Application for Variation of an Environmental Permit

C2. Application No. of the Current Environmental Permit : AEP-393/2010

**Agreement No. CE 6/2015 (EP)
West New Territories (WENT)
Landfill Extension – Design and
Construction**

Supporting Document for Variation
of Environmental Permit

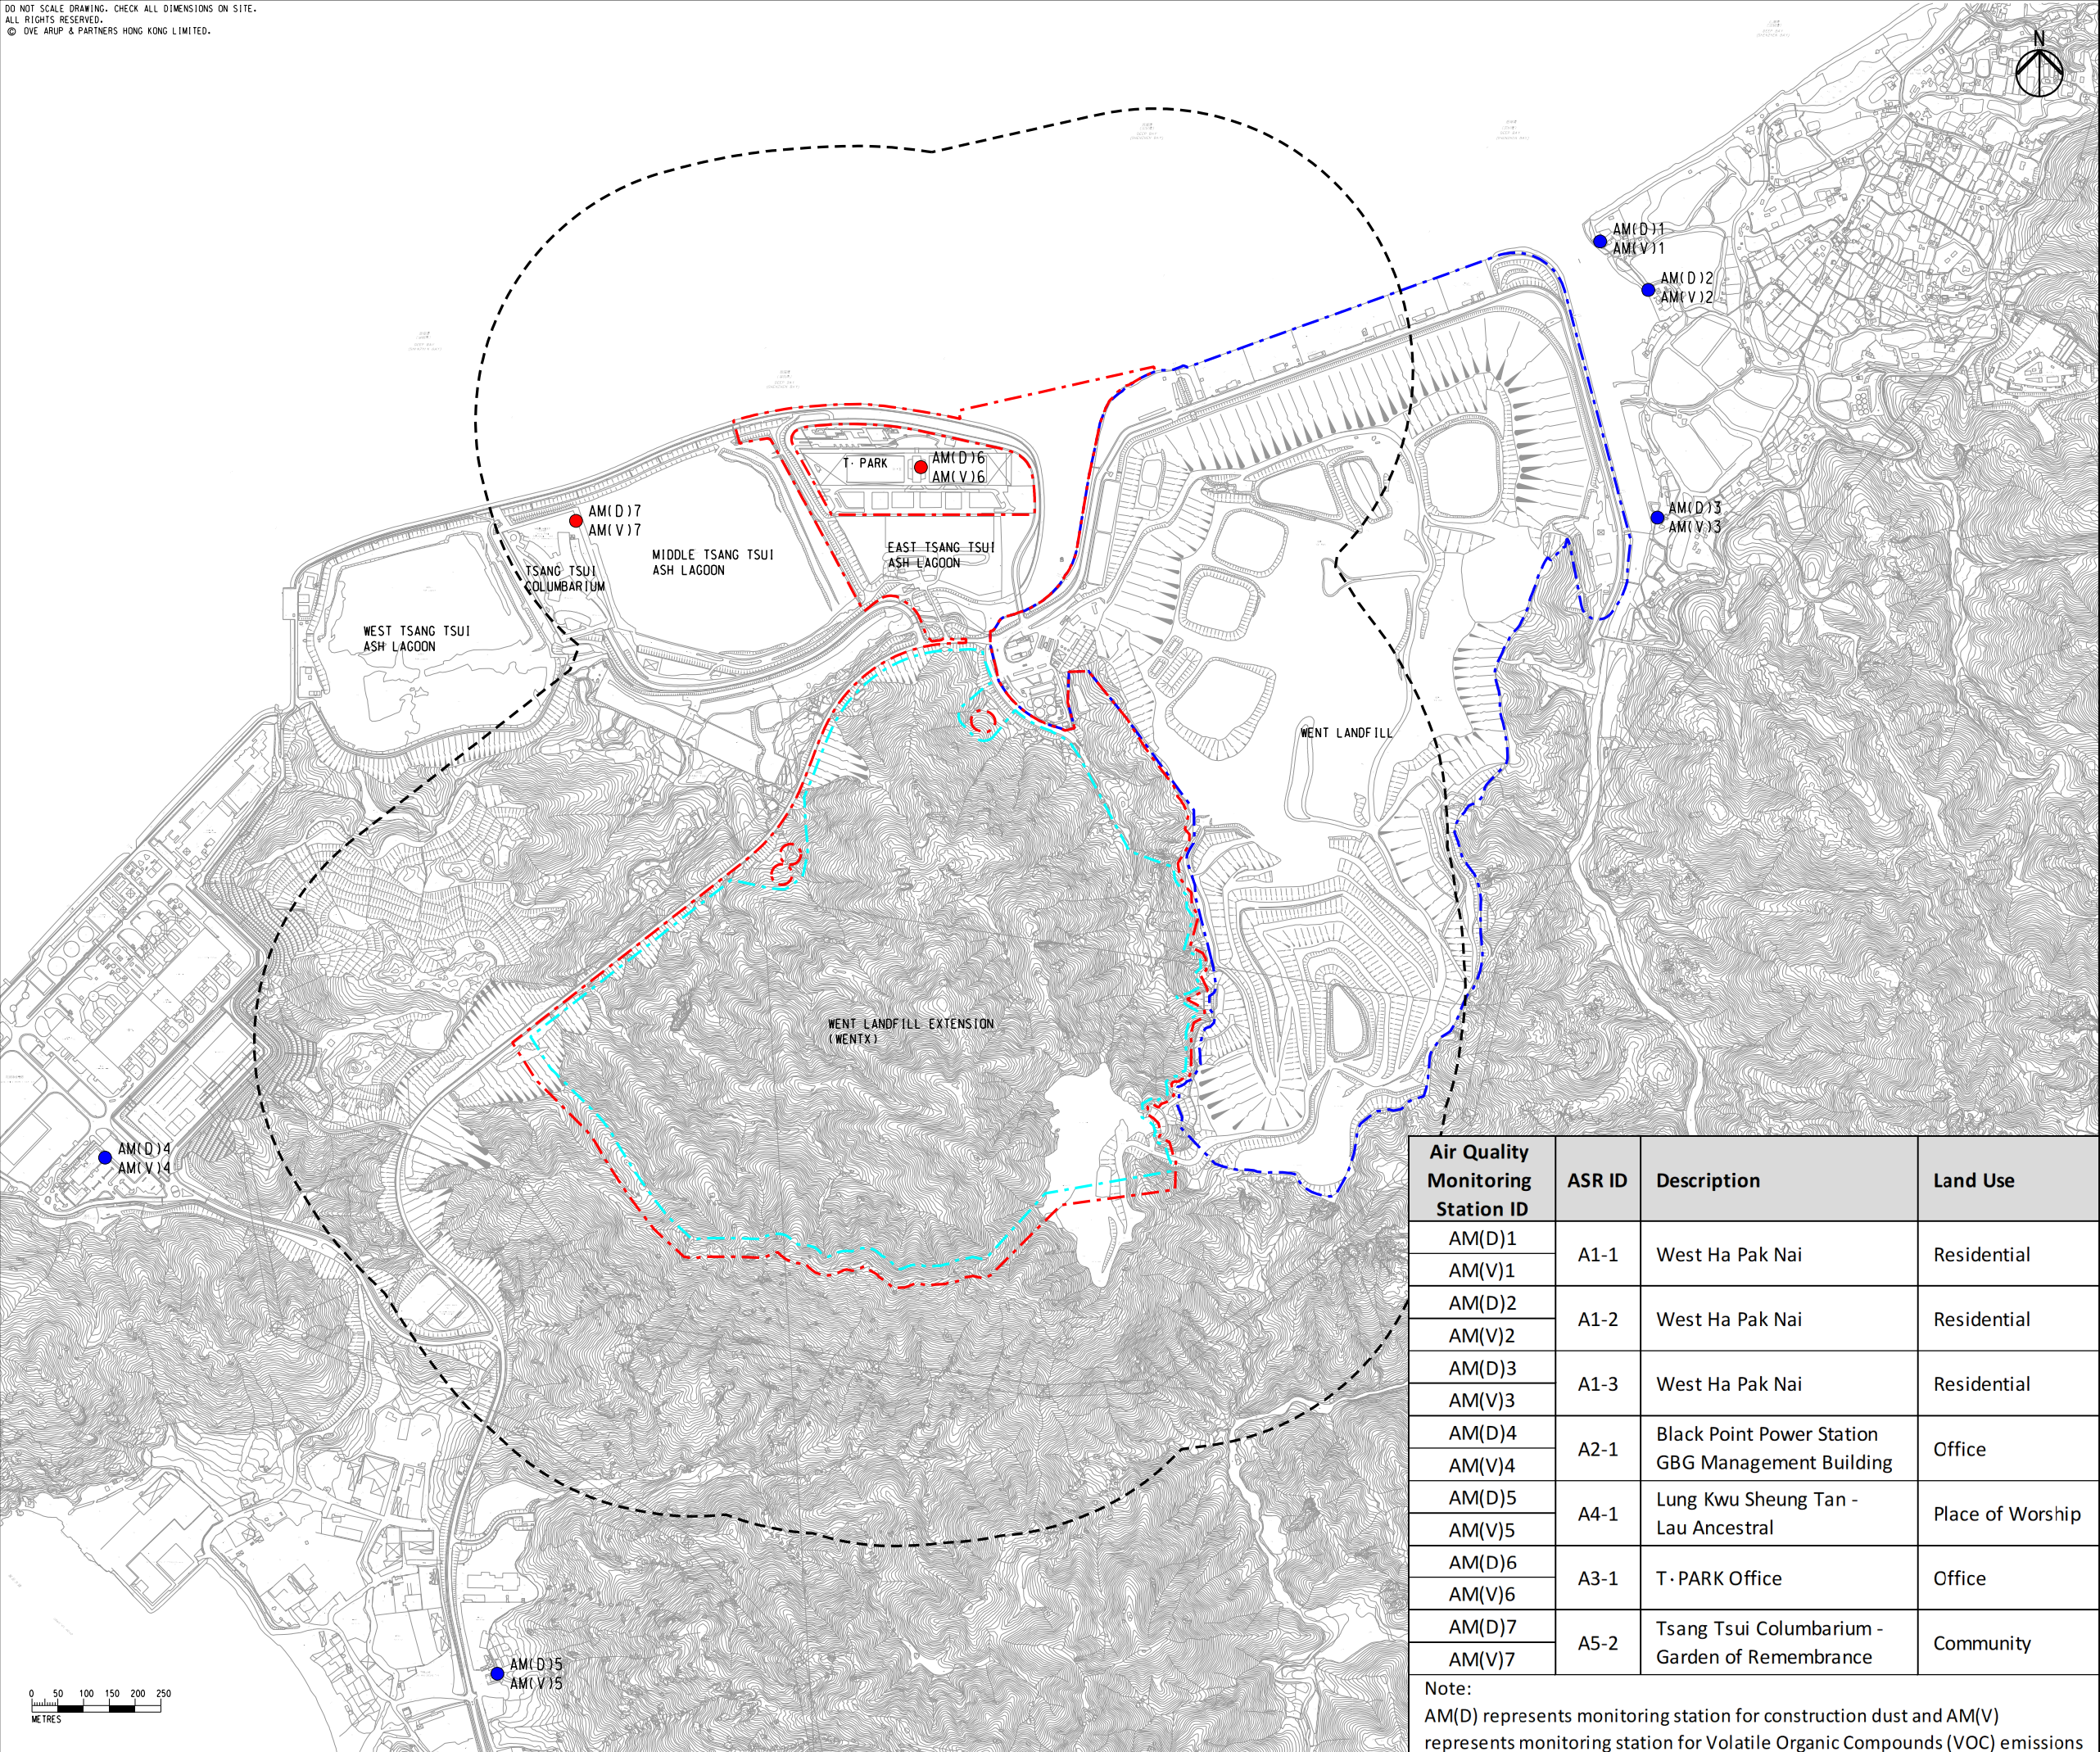
3.1.9 The EM&A programme as specified in the EM&A Manual shall be implemented to detect any deteriorating air quality and rectify the situation in a timely manner. No change on the recommended air quality monitoring locations is proposed. However, additional monitoring stations at T • PARK office and Tsang Tsui Columbarium are recommended (**Table 3.3** and **Figure 3.2**).

Drawing no.	FIGURE 4.1	Rev.	A
-------------	------------	------	---

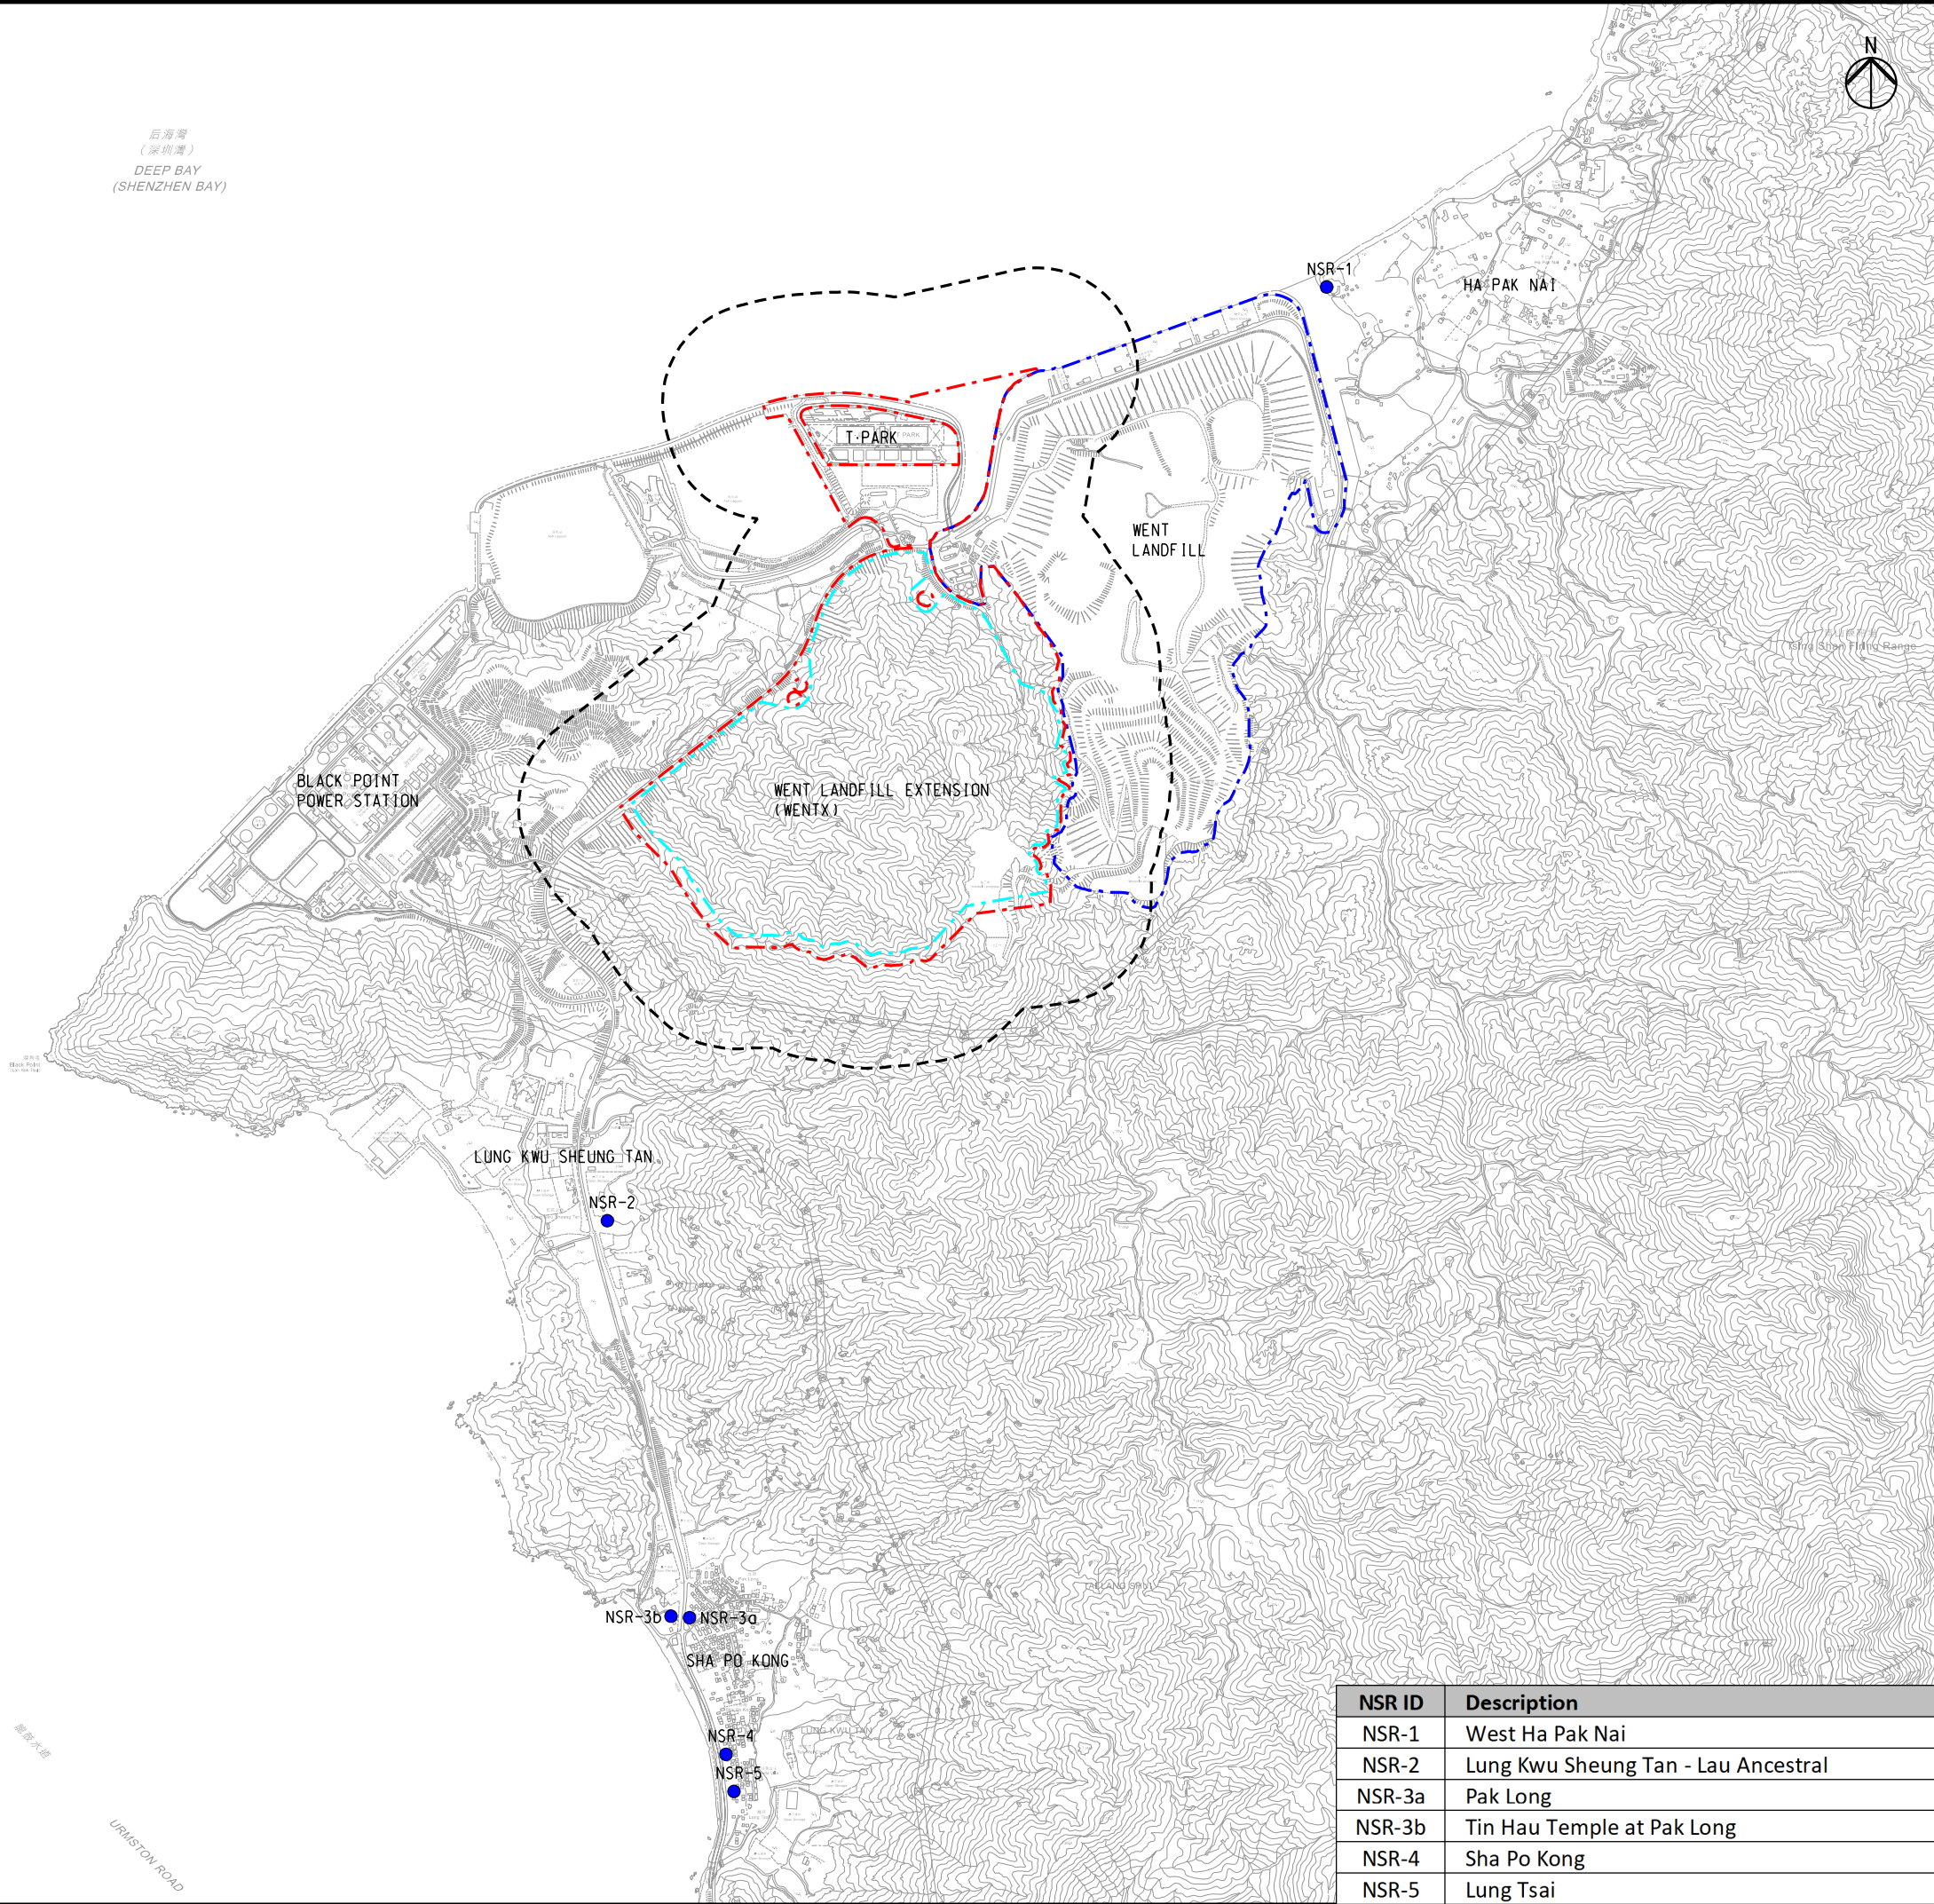
4.1.6 The EM&A programme as specified in the EM&A Manual shall be implemented to detect any odour and rectify the situation in a timely manner. No change on the odour patrol locations as recommended in the approved WENTX EIA is proposed. Due to the reduced waste boundary, two proposed odour patrol locations at the Project boundary need to be adjusted. Additional odour patrol location at Tsang Tsui Columbarium is also recommended (**Table 4.2** and **Figure 4.1**).

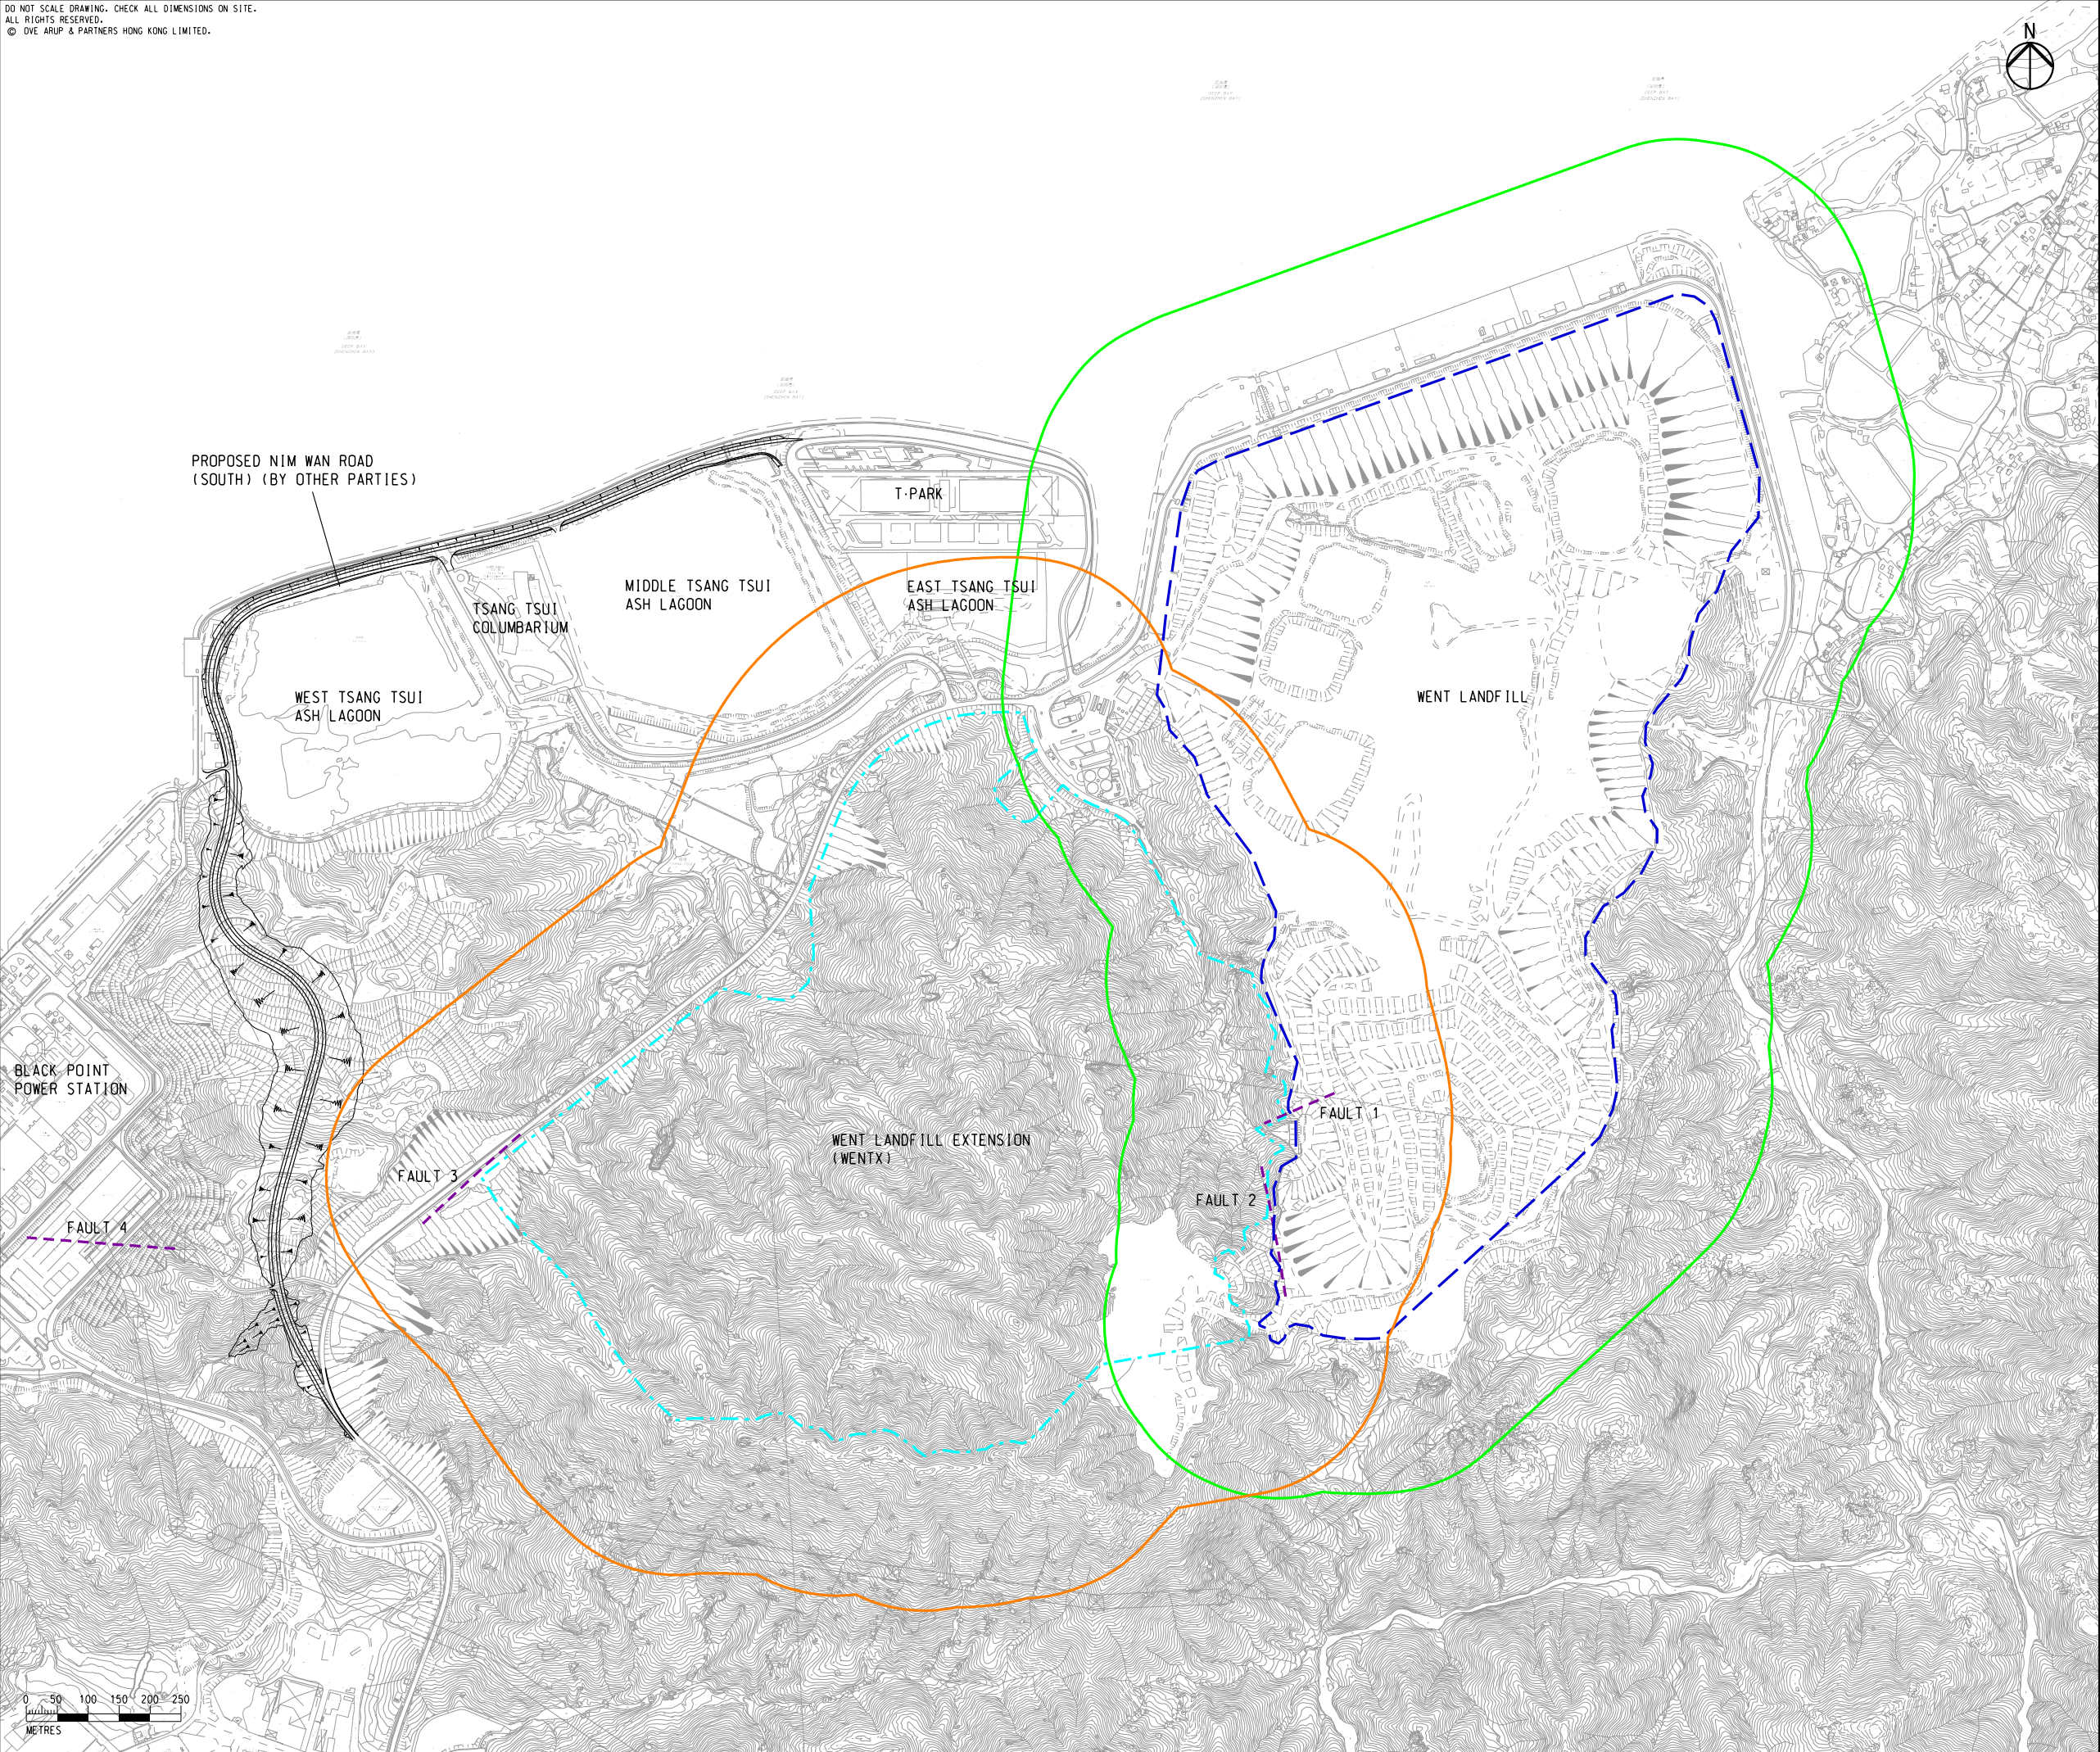
9.1.1 Due to the reduced size of waste boundary, the extent of 250 m consultation zone has been revised. All the receivers outside WENTX will no longer fall within the 250 m consultation zone of the WENTX (**Figure 9.1**). Potential landfill gas (LFG) hazard impact is therefore not anticipated.
